### NEEDHAM PLANNING BOARD

### Tuesday November 16, 2021 7:00 p.m.

7:20 p.m. Amendment to Major Project Site Plan Special Permit No. 2009-06: Town of Needham, 1471

8:30 p.m. Major Project Site Plan: Needham Enterprises, LLC, 105 Chestnut Street, Suite 28, Needham,

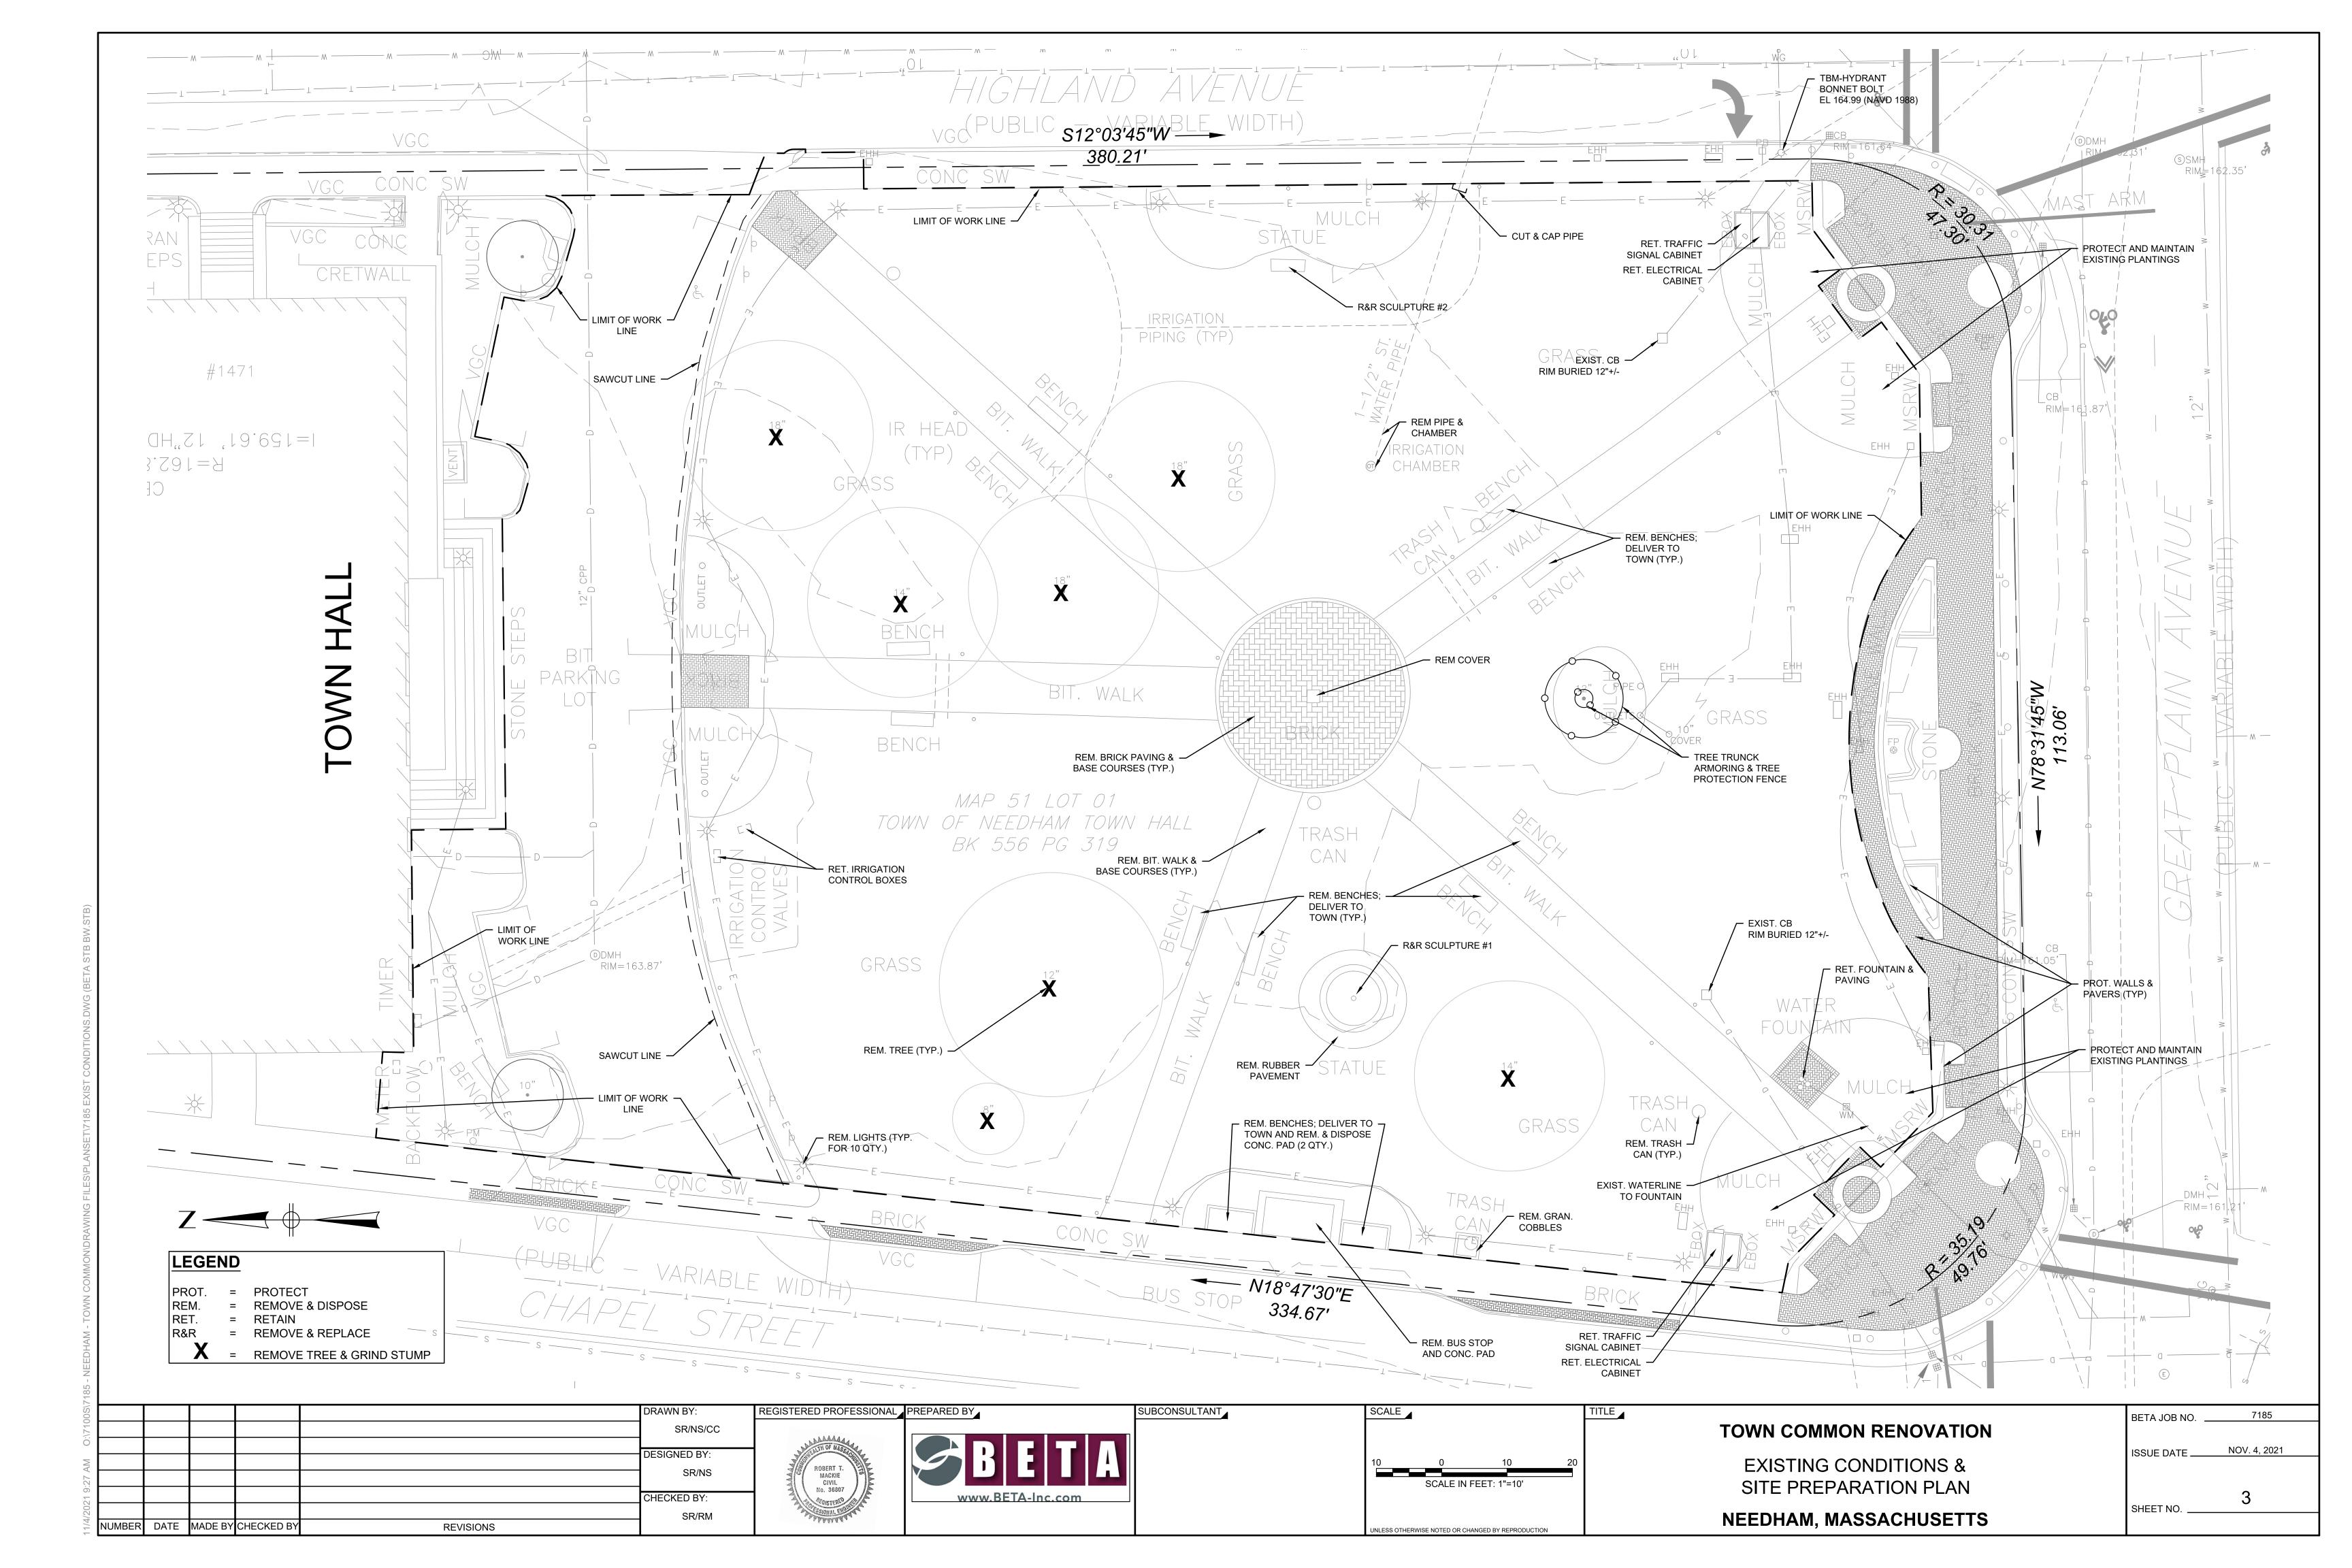
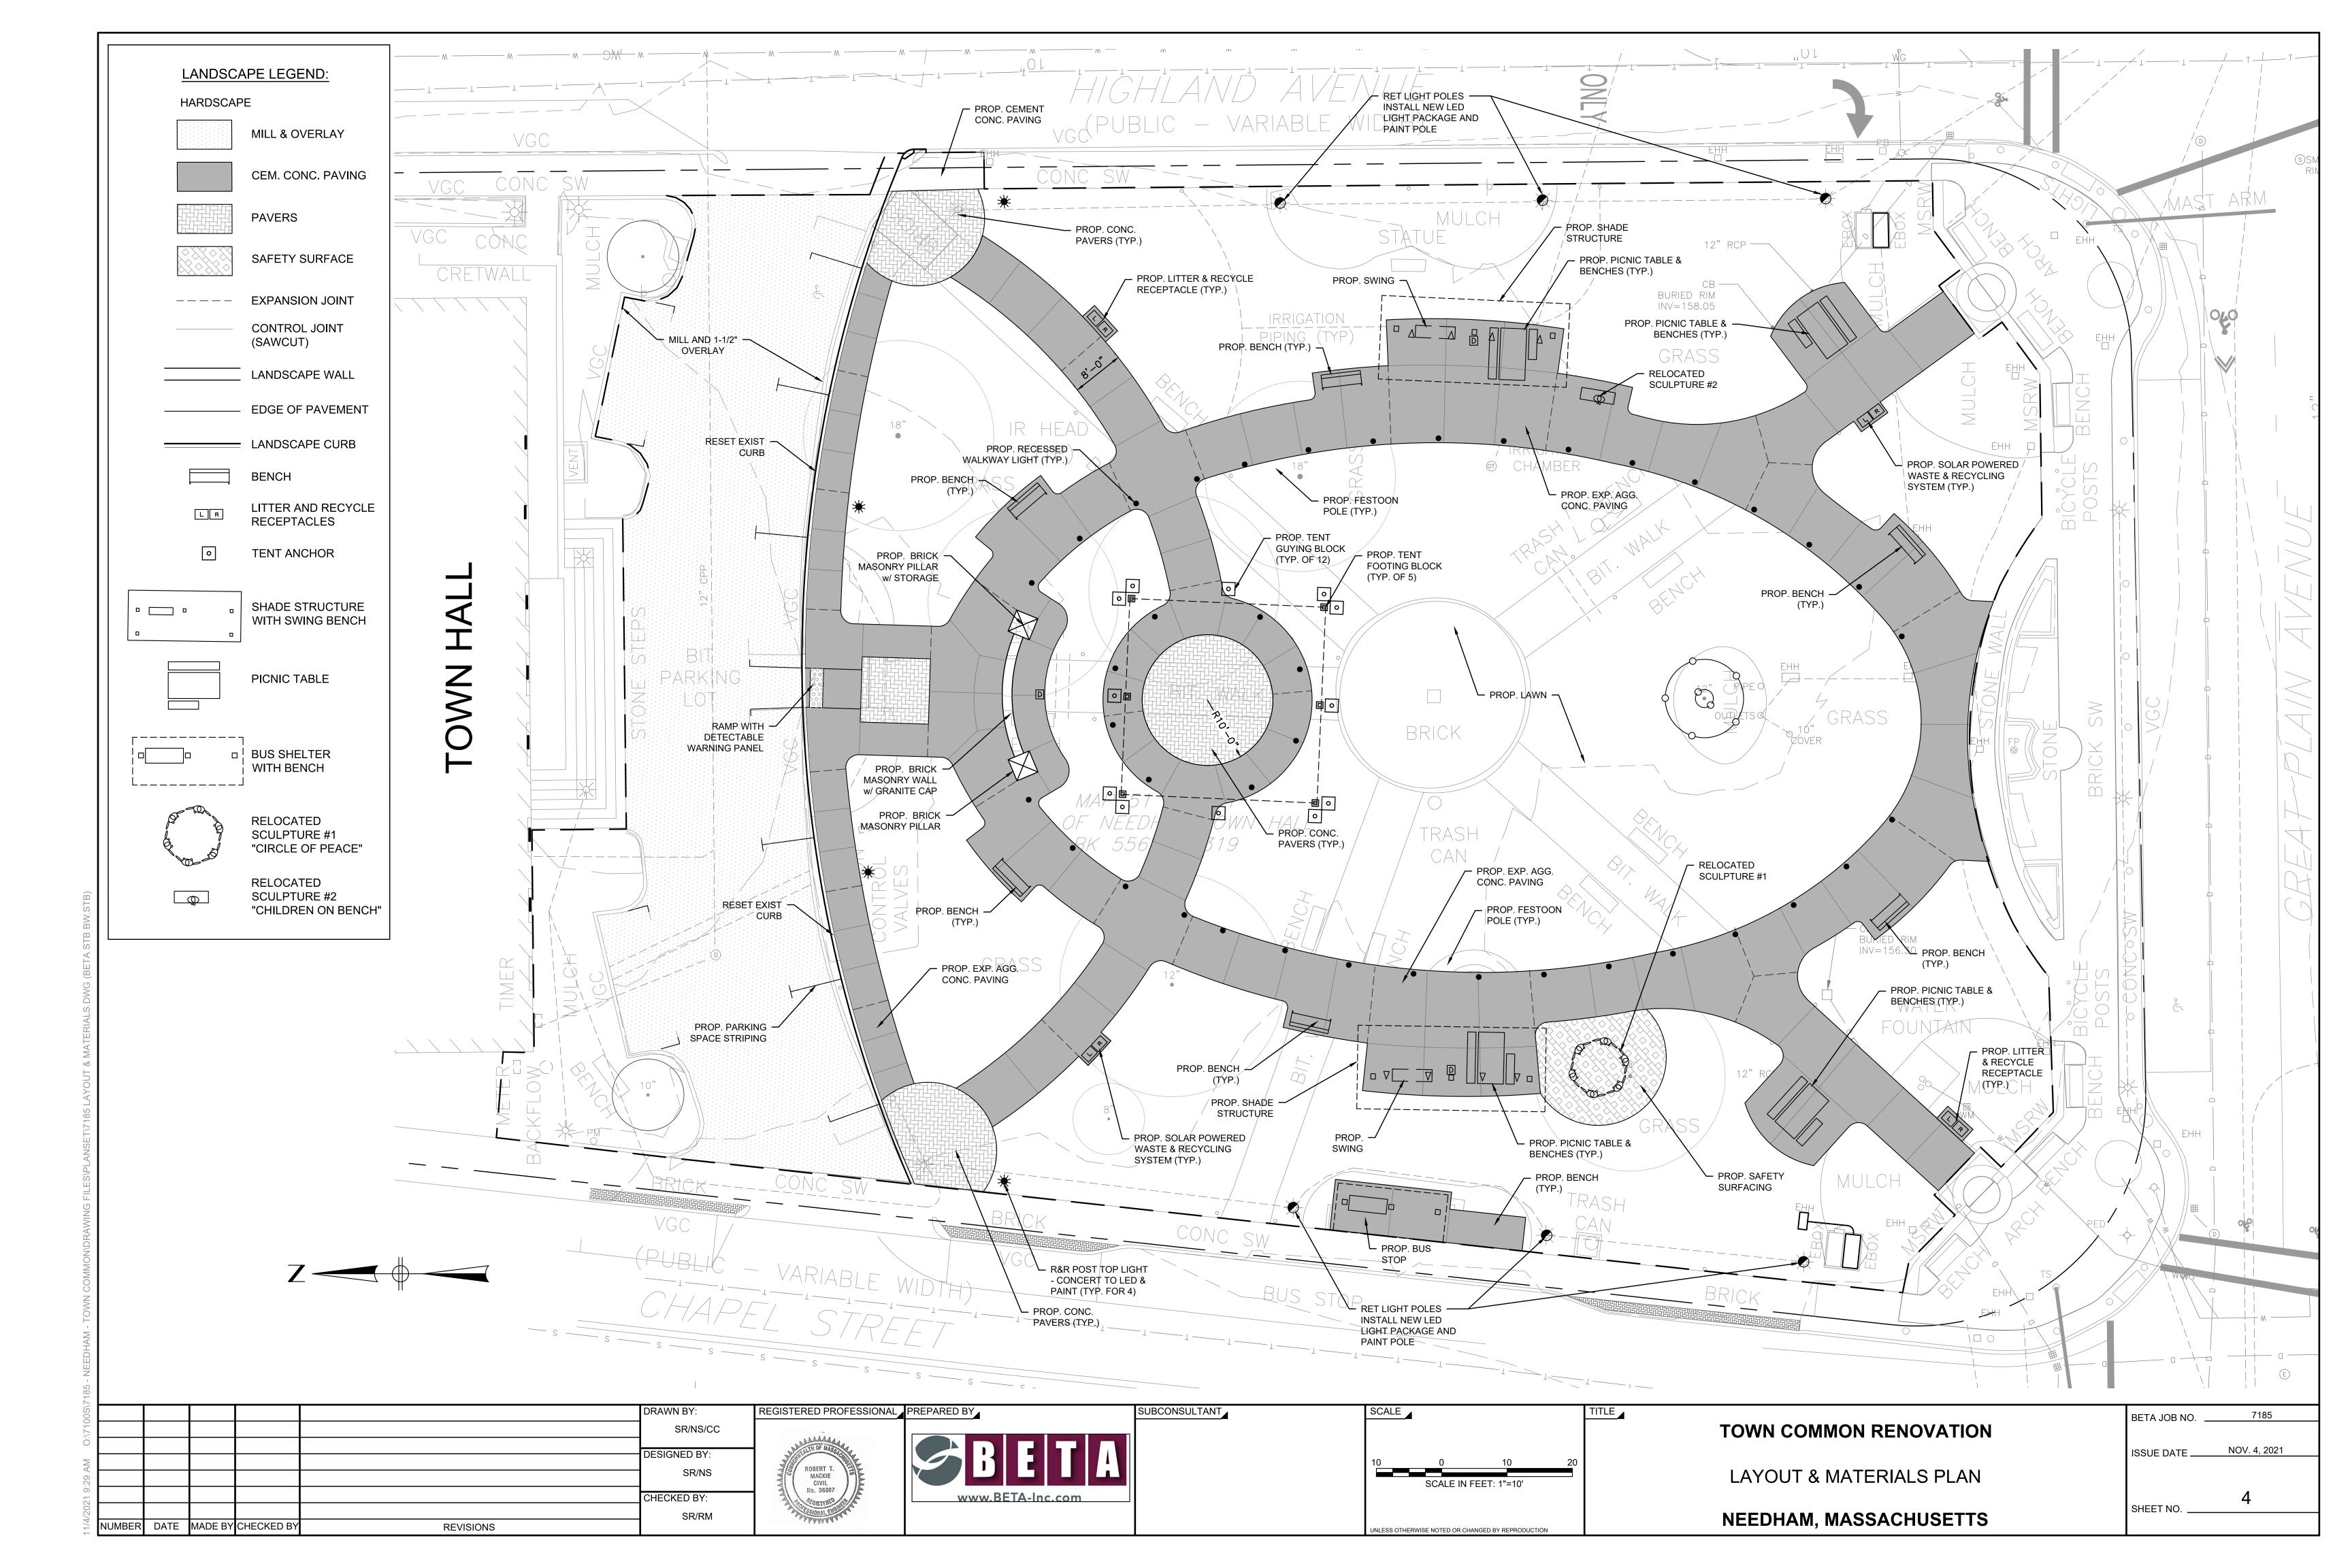
- The brick masonry seat wall at the north end of the site has been redesigned to include brick pillars on each end of the wall. The new pillars have been designed to be similar in appearance to the existing pillars at the end of the walls along Great Plain Avenue. One of the new pillars will be constructed to house PA outlets, wiring, etc. for use during events on the Common. The PA equipment itself will be stored inside Town Hall when not in active use during events. Renderings of the redesigned wall are included as figure (a) below, and on Sheet 12 (Details) of the revised plan set.

- The six (6) temporary festoon poles shown on the original plans have been removed, although the temporary festoon lighting will remain. In place of the free-standing poles, the proposed shade structures located on the east and west sides of the lawn will now include fixtures upon which cables and festoon lights can be affixed. This is illustrated on figure (b) below, and on Sheet 6 (Electrical Plan) of the revised plan set.
